January 31, 2015

Re: Addendum #3 Roof Replacement Project The Laundry Building Herman M. Holloway Sr. Campus - Contract No. MJ3505000027

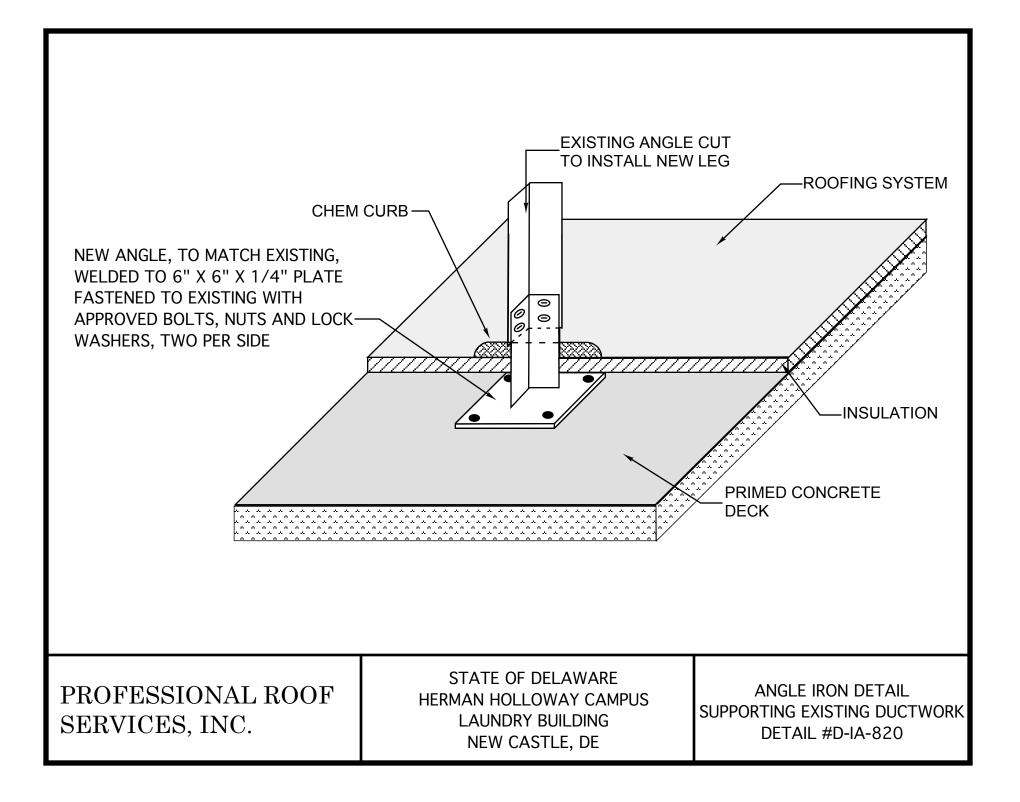
1. The capped curb located in the northeast corner of the roof that the air conditioning unit and pitch pockets will be removed from as referenced in Addendum # 2 is a structural concrete curb. This curb will then be flashed using the Tuff Flash Flashing System at I Beam Locations detail given in the specification #D-SC-610.
